**CITY OF PORTLAND, MAINE  
DEVELOPMENT REVIEW APPLICATION  
PLANNING DEPARTMENT PROCESSING FORM**  
-Planning Copy

Relocation of House  
Project Name/Description

RE: Application for Single Family House Relocation, Brewer Street, ID # 2005-0120

17 Brewer St.  
#2005-0120  
Minor Site Plan  
Receipt of  
appl. notice sent  
to immediate  
author.

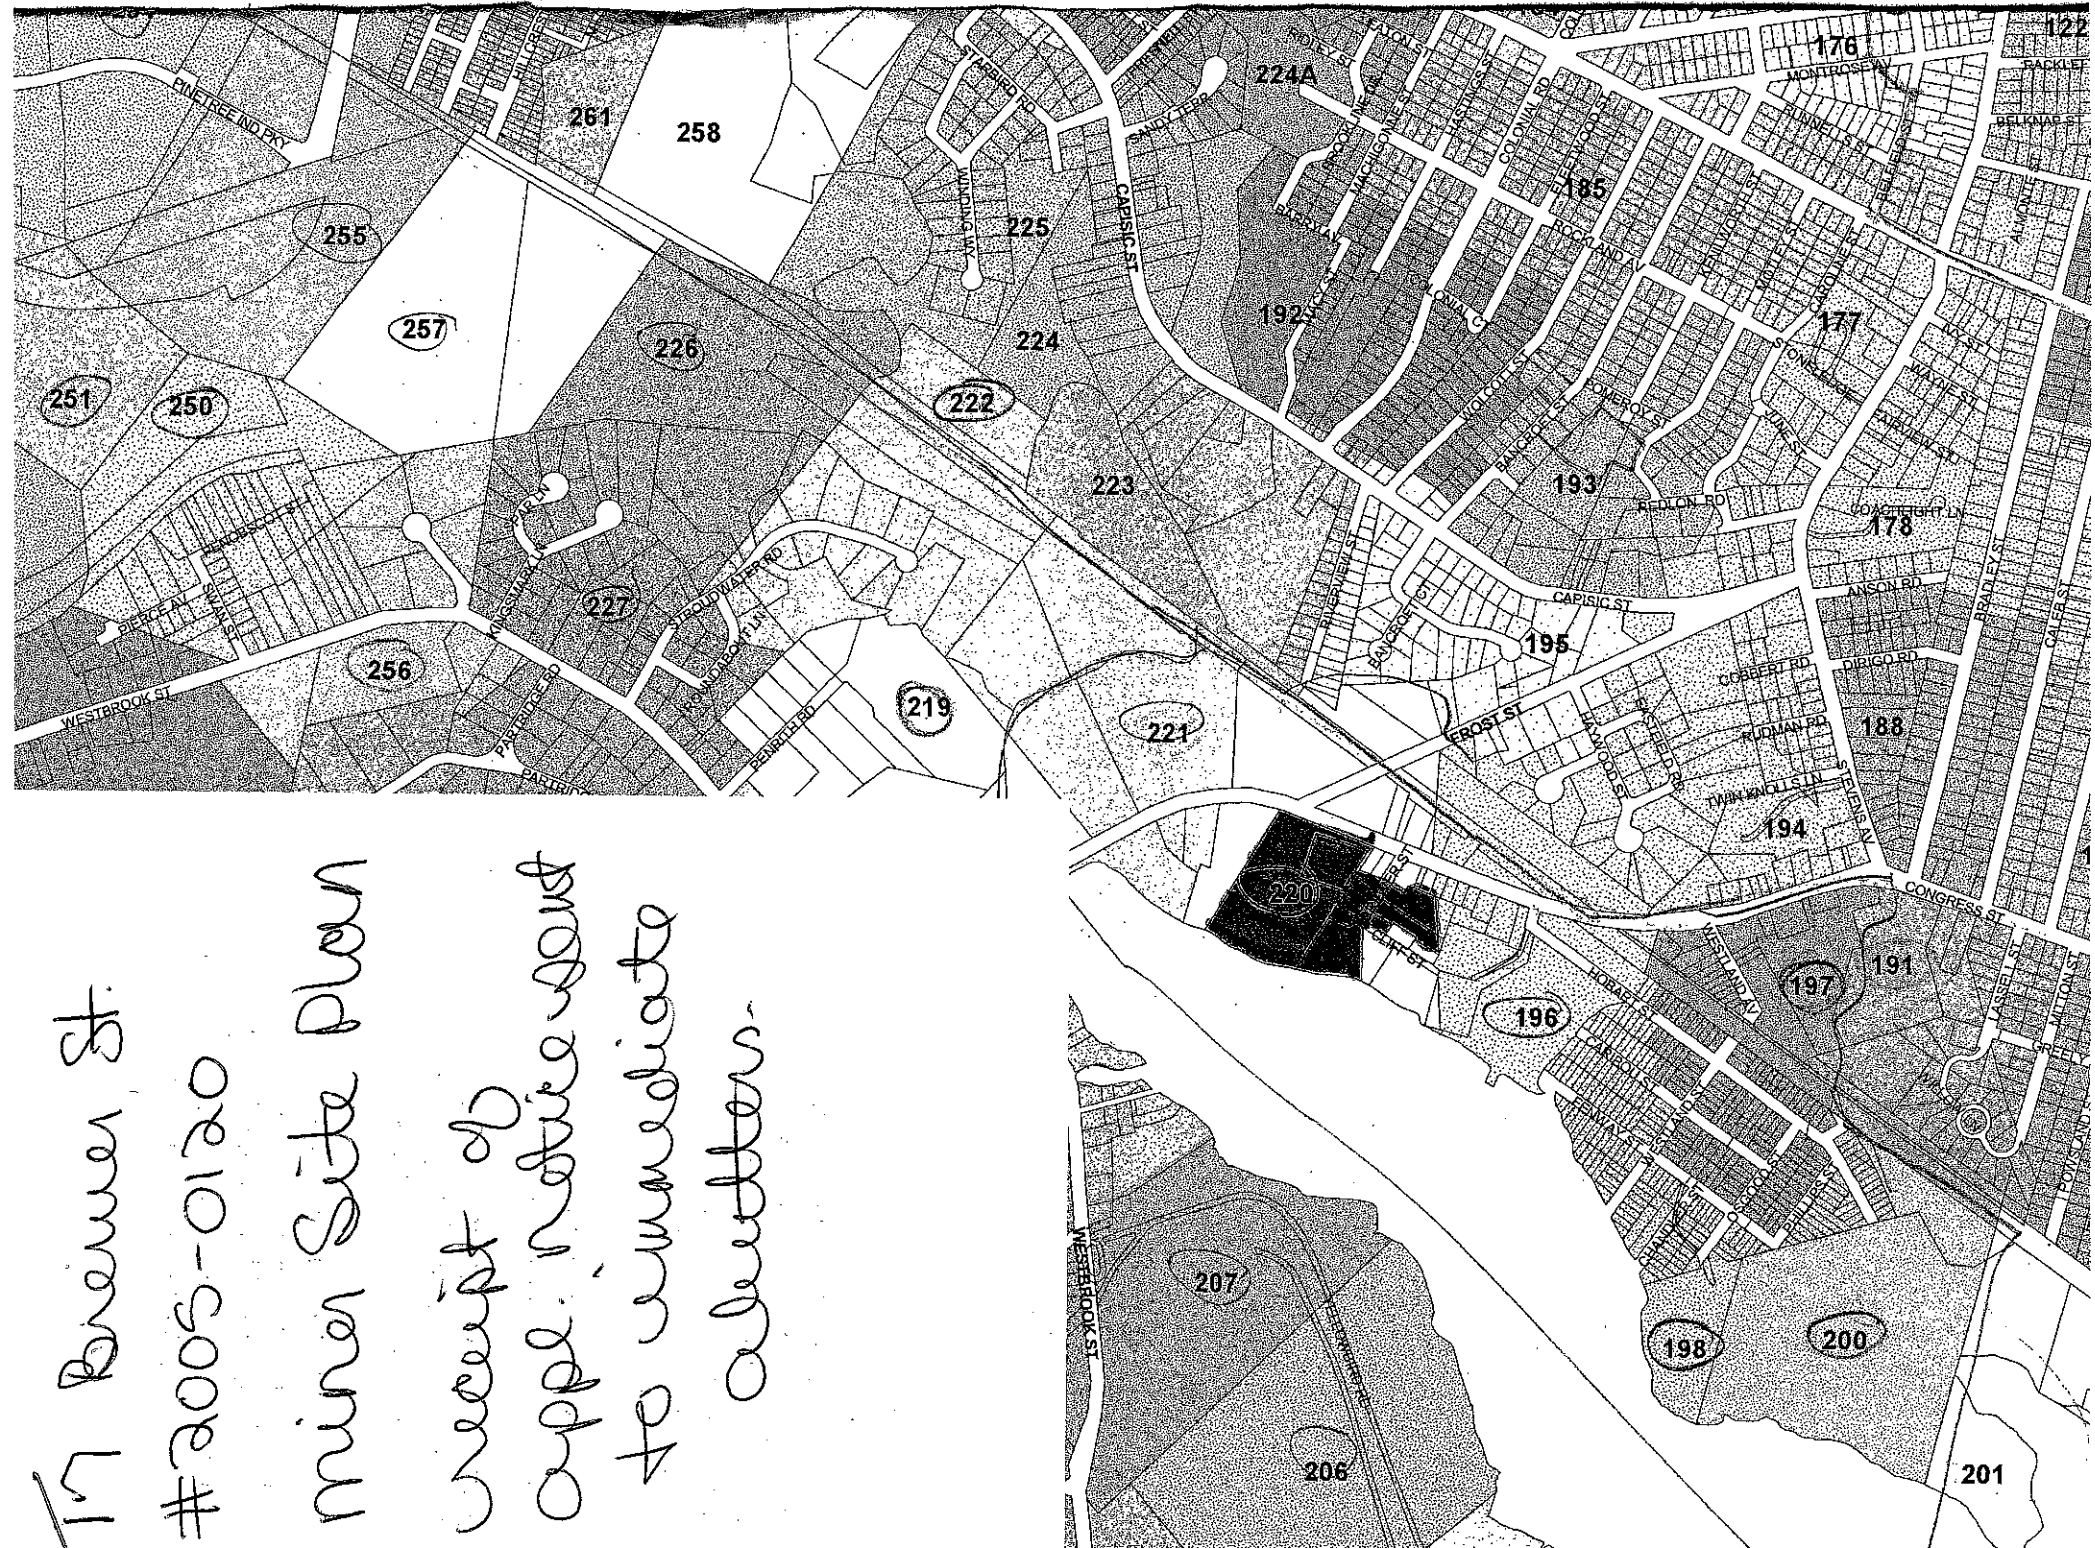
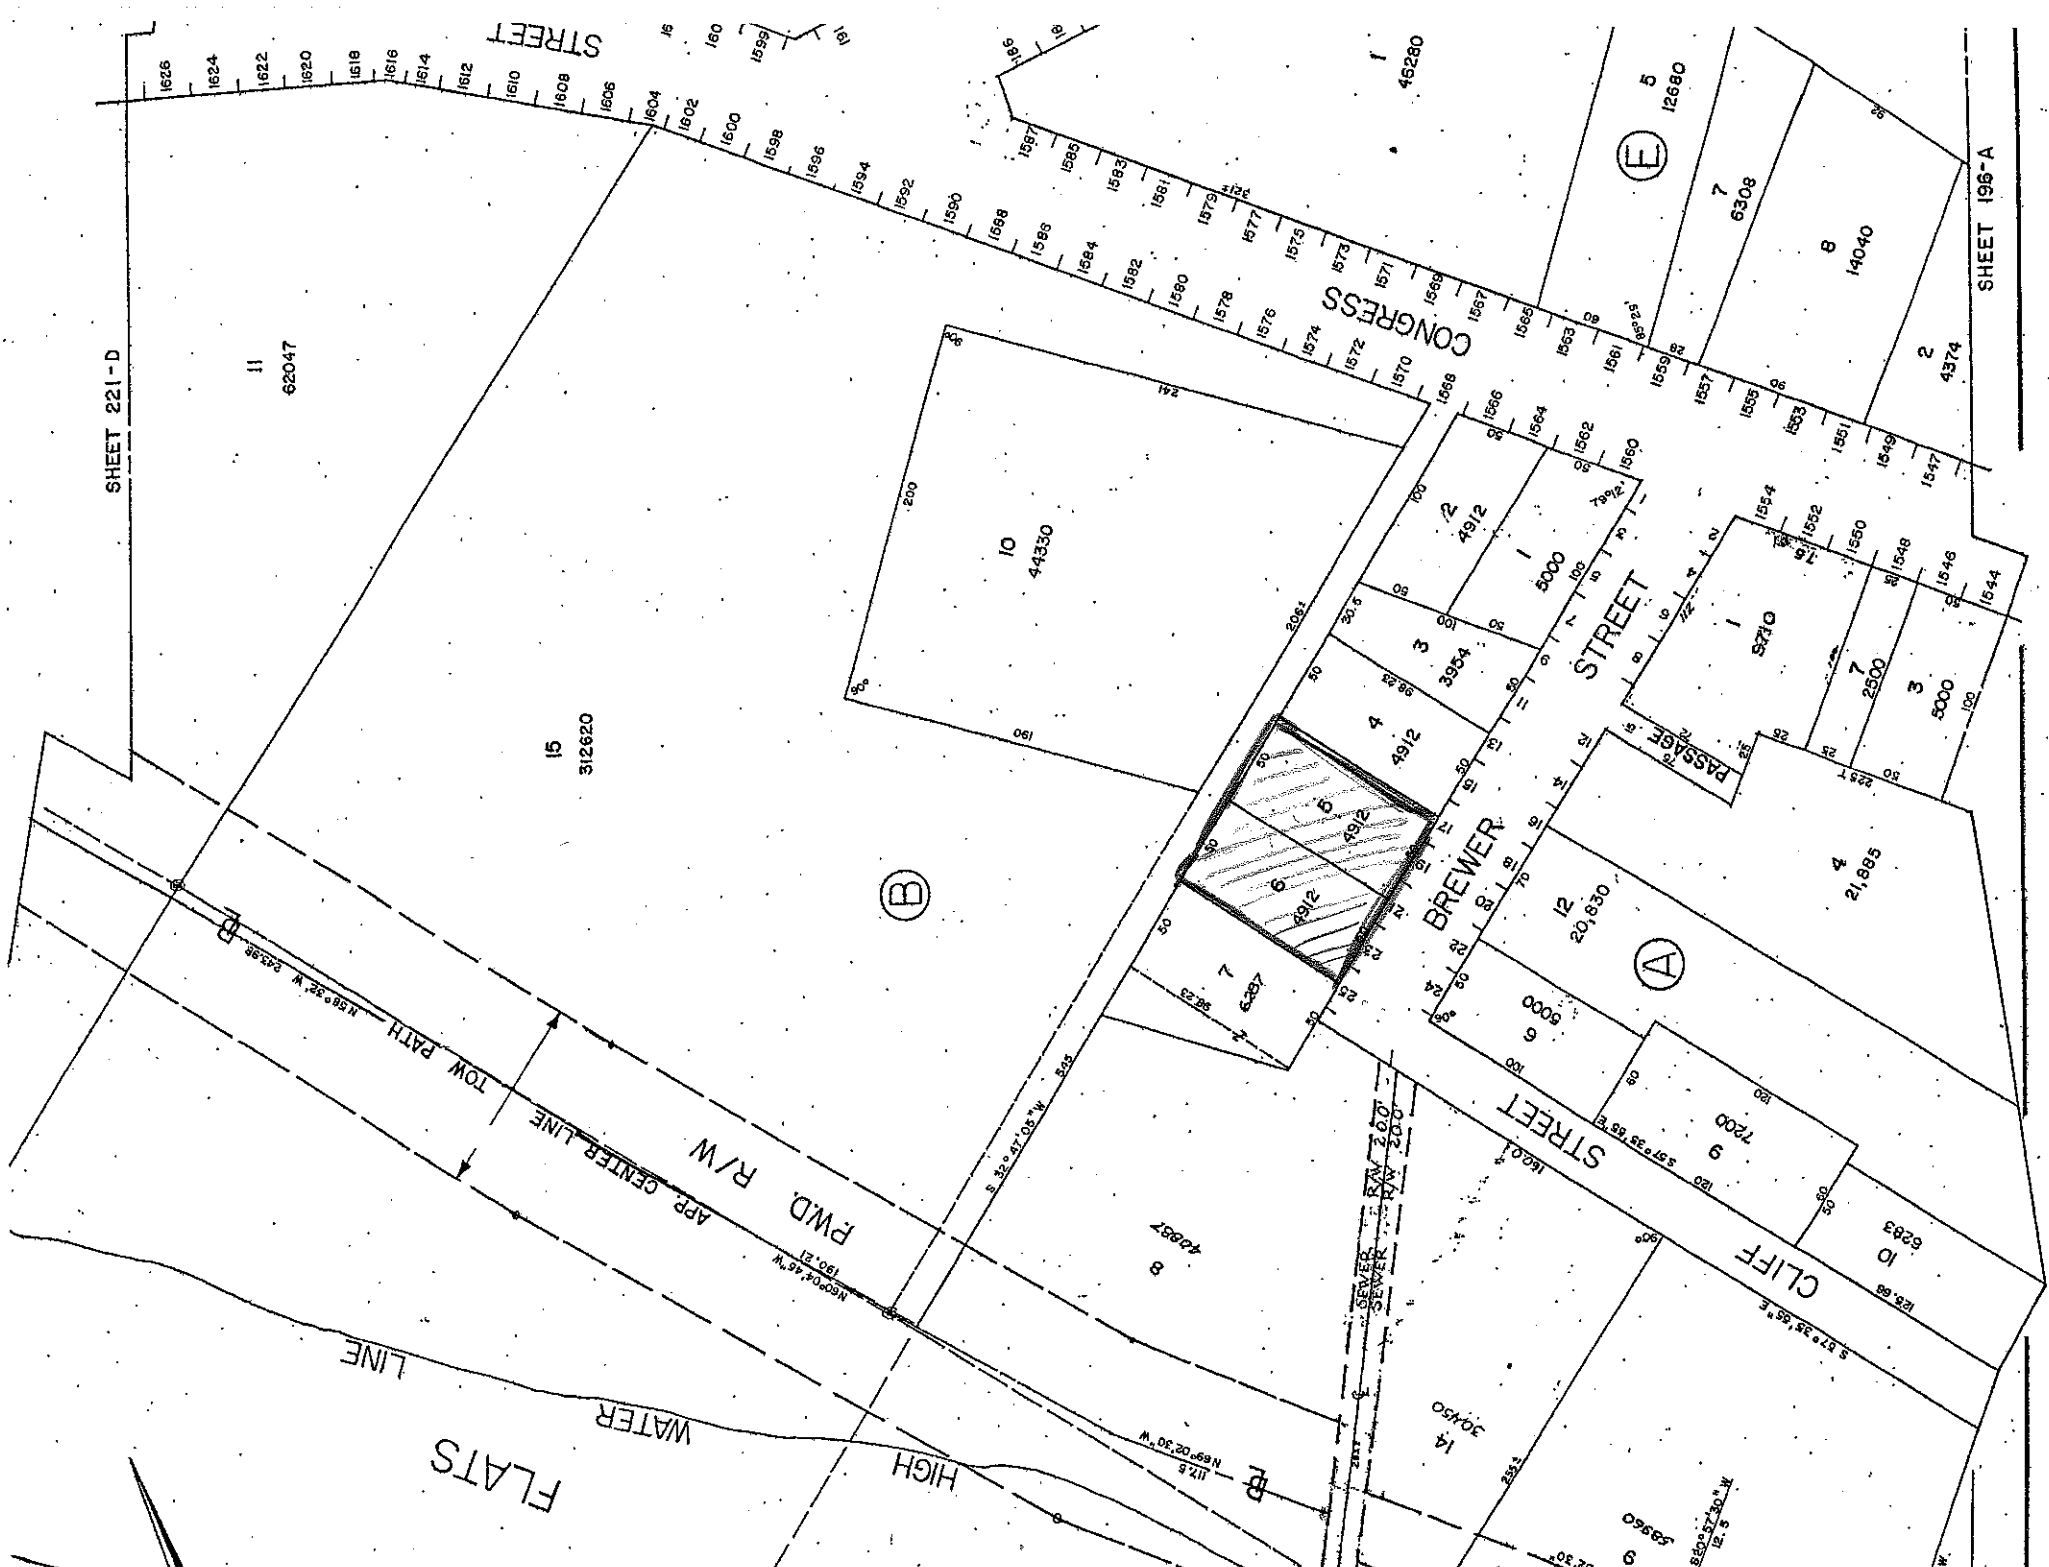
Thank you for your application to relocate a single family home from #1563 Congress Street to your lot on Brewer Street. Upon review of the site plan, the City's Planning Division has the following comments:

1. 4 parking spaces, 9'x19' each, are required (2 per unit). Please add 4<sup>th</sup> space to the site plan. Note: parking in the R-5 zone must be outside of the front setback.
2. Relating to item #1, it may be possible to add the 4<sup>th</sup> space in front of the garage and eliminate the proposed curb cut and paved driveway in front of the new building. Please consider.
3. Please show proposed topography/grading on your site plan.
4. Add erosion control (silt fence) as applicable.
